# Amity College, Leppington Modification 3

State Significant Development Modification Assessment  
(SSD-9227-Mod-3)

January 2022

**Figure 4 |** Proposed roof ridge amendments and visual and acoustic screening (Source: Modification Application)

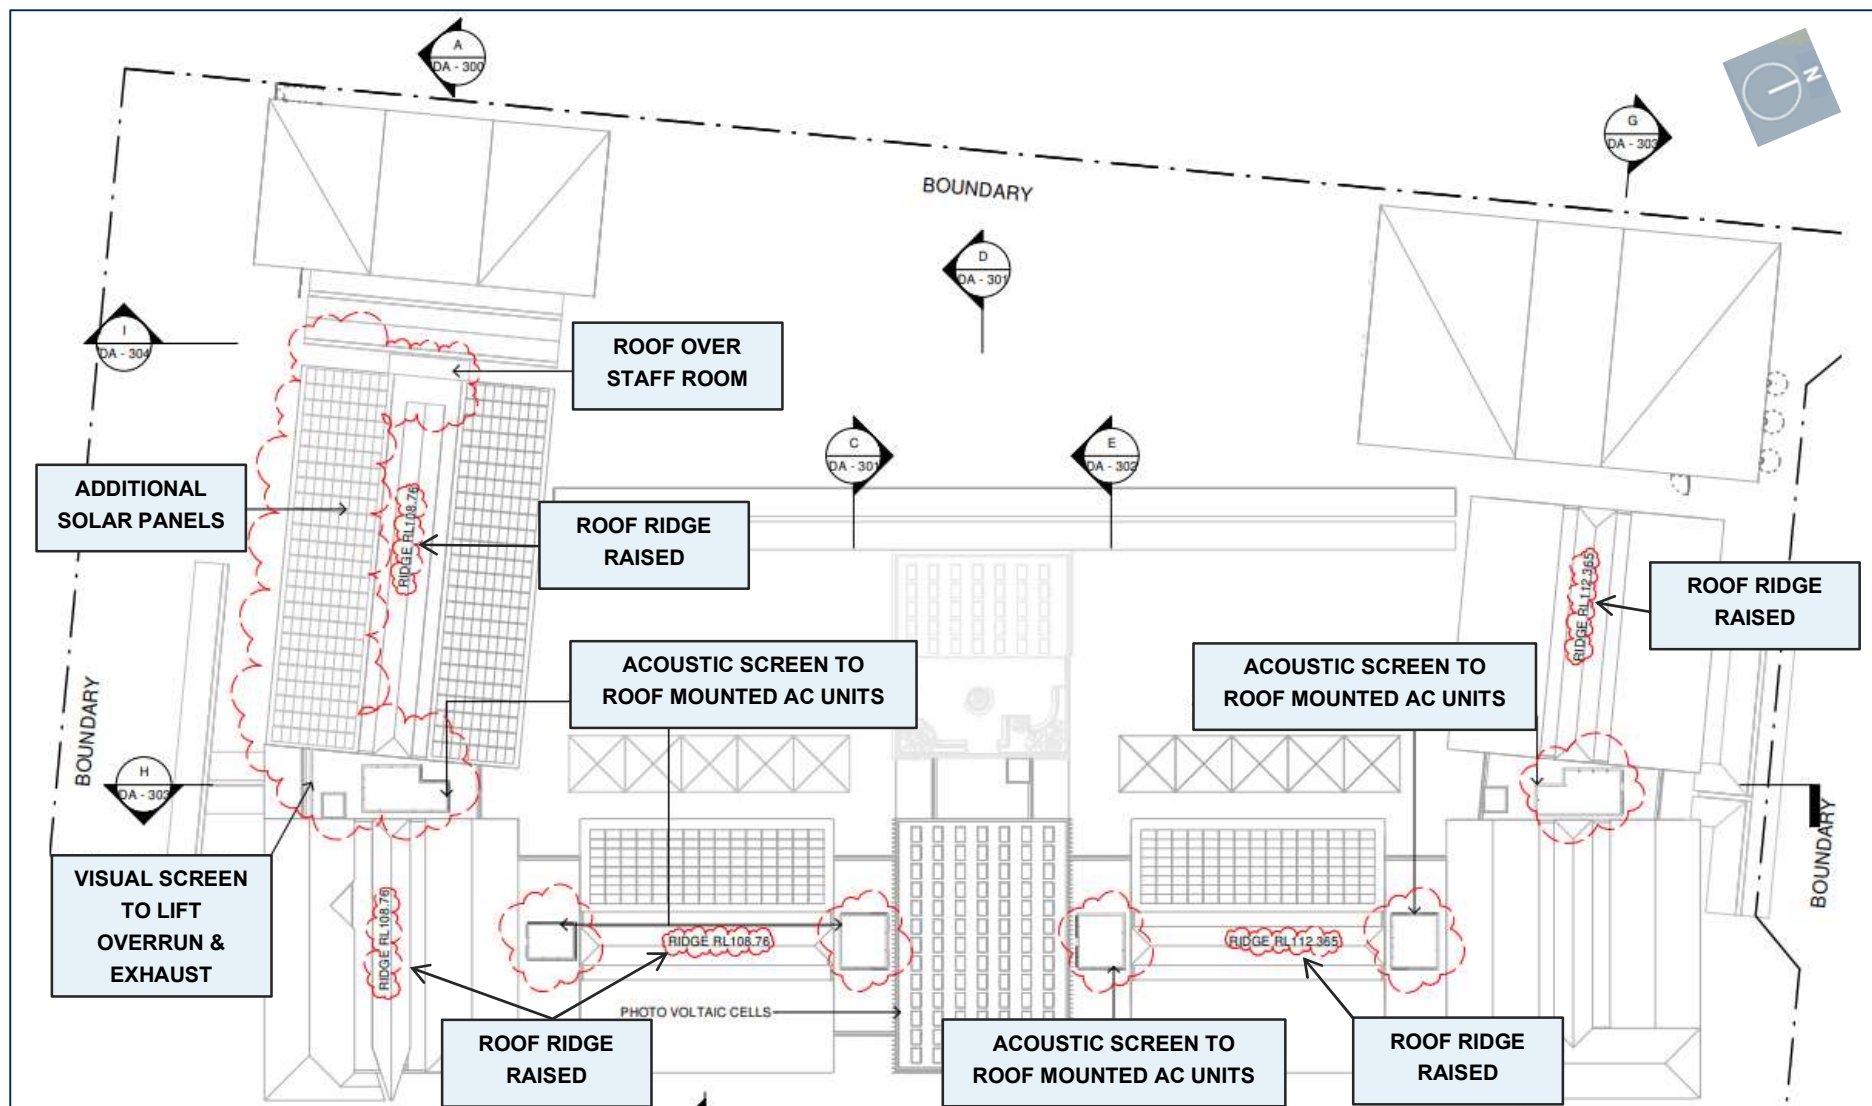
The modification application proposes to raise the ridge height of the central corridor clerestories to the primary and secondary school wings to maintain the light and ventilation to the school classrooms. The Applicant's modification report stated that the structural requirements for the roof and framing (as currently approved) would reduce the operable height of the clerestory windows, and therefore, reducing the quality of natural light and ventilation.

The proposed RLs of the primary school and the secondary school building's clerestory ridges would be raised to RL108.76 and RL112.37, respectively, which still are lower than the approved roof level of the central block of RL 114.24.

The Applicant's modification report stated that the proposed increase in height would not have a significant detrimental visual impact or cast shadow on any of the neighbouring properties. The proposed amendments are shown in **Figure 4** (refer **Section 2**).

The modification application proposes acoustic screening to the rooftop mounted air-conditioning (AC) units located on the flat roof sections to comply with the conditions of consent.

The Applicant's modification report indicated that the top of the screens would be lower than the adjacent pitched roofs. The proposed colour of the acoustic screens would match the adjacent pitched roofs, and the material and colour of the visual screen would match the approved building facade batten screens.

The Department notes that no height of buildings control is specified for the site under the Growth Centres SEPP and accepts the Applicant's justification that the minor increase in the roof ridge height would improve internal lighting and ventilation to the school classrooms. The Department also accepts that it would not significantly increase the bulk and scale of the approved development and would have a negligible visual and overshadowing impacts.

The Department acknowledges the proposed acoustic and visual screening of the building's rooftop plant and lift overrun is required to ensure compliance with the conditions of consent and the relevant Australian standards.

**Figure 5** | Roof amendments shown at the northern elevation (Source: Applicant's Modification Report 2021)

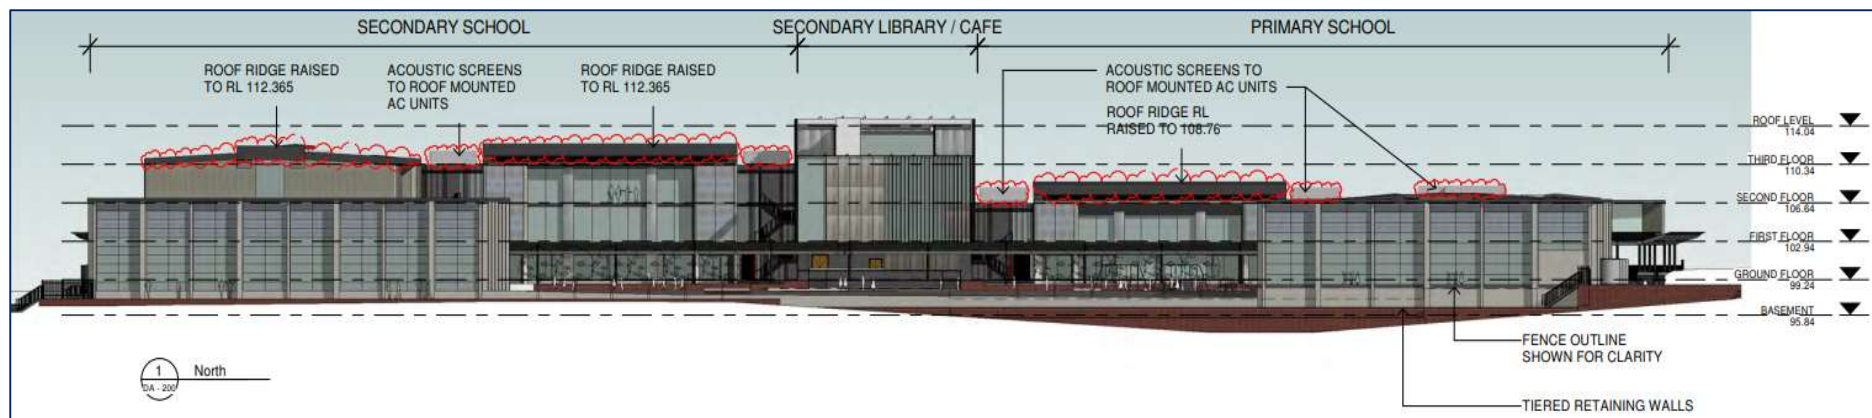
The modification application proposes a minor increase in roof height (the central corridor clerestories) to both the primary and secondary school buildings. An increase of between 0.34 metres (m) and 1.11m is proposed to address the structural requirements for the roof while maintaining adequate lighting and ventilation to the primary and secondary school classrooms.
